AMENDMENT NO. 2 SEPTEMBER 2024

IS 16192 (PART 3) : 2018 AUTOMOTIVE VEHICLES — WHEEL RIMS FOR TWO AND THREE WHEELED VEHICLES

PART 3 SPOKE WHEEL RIMS — METHODS OF TESTS AND REQUIREMENTS

Amendment No. 2 to IS 16192 (Part 3) : 2018

FIG. 1 LOAD APPLYING METHOD'

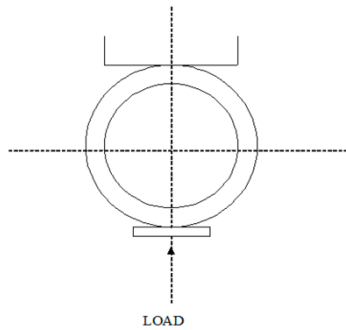
(Page 1, clause 4.2) — Substitute the following for the existing:

Place the rim vertically on the base having a plane of not smaller than a horizontal rim width and add the load gradually, as per Fig. 1 to the rim, toward the direction of vertical centre of rim from the most outside circumference part of rim.

4.2.2.1 When the deflection of wheel rims (without wired spokes) has attained a value given in Table 1 by applying a load by the method given in Fig. 1 to the rim, the load shall not be smaller than the value given in Table 2 and in addition, the rim shall be free from cracks.

4.2.2.2 For the sizes not available in Table 1 and Table 2, when the deflection of wheel rims (without wired spokes) has attained a value as declared by wheel rim manufacturer, applying a load by the method given 4.2.1 to the rim, the load shall not be smaller than the value declared by wheel rim manufacturer and in addition, the rim shall be free from cracks.

FIG. 2 CYLINDRICAL BEAD SEAT RIM CONTOURS

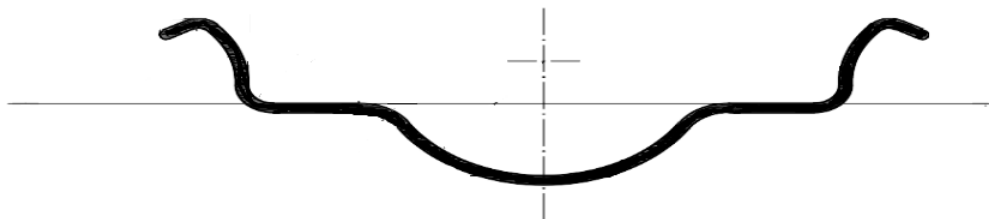
(Page 2, clause 4) — Insert the following after 4 and renumber the subsequent clauses

5 RIM CONTOUR (FOR REFERENCE ONLY)

A rim contour for cylindrical bead seat rim is given at Fig. 2.

FIG. 3 5° TAPERED BEAD SEAT RIM CONTOURS (MT TYPE)

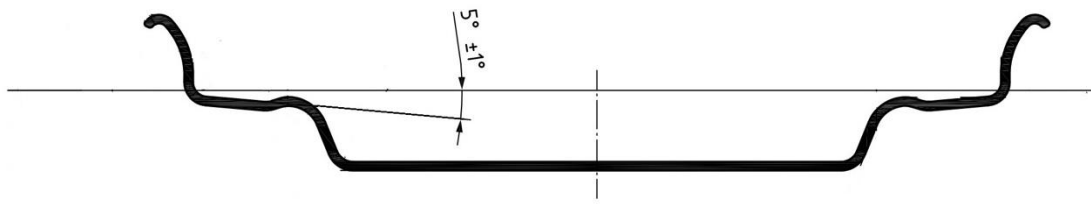
5.2.1 Rim contour for 5° tapered bead seat rim with hump is given in Fig. 3, rim contour for tapered bead seat rim with hump and well contour is given in Fig. 4 and rim contour for tapered bead seat rim without hump is given at Fig. 5.

FIG. 5 TAPERED BEAD SEAT CONTOURS FOR RIMS WITHOUT HUMP'

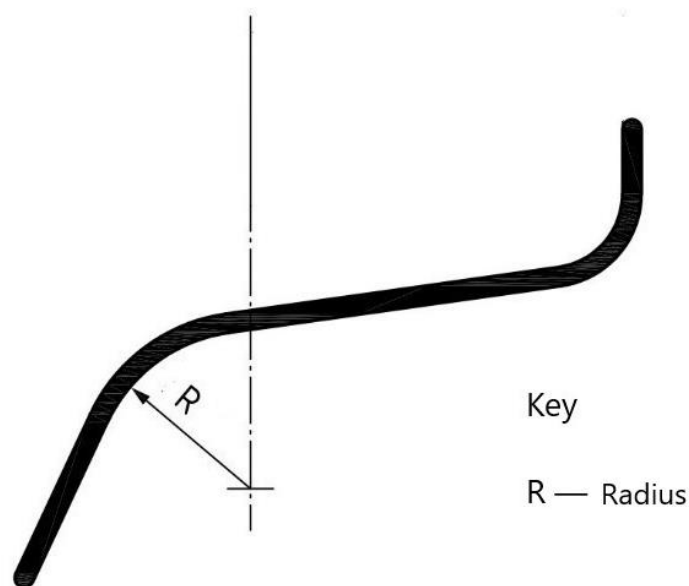
5.2.2 Rims without hump shall only be used with tyres for tube type application.
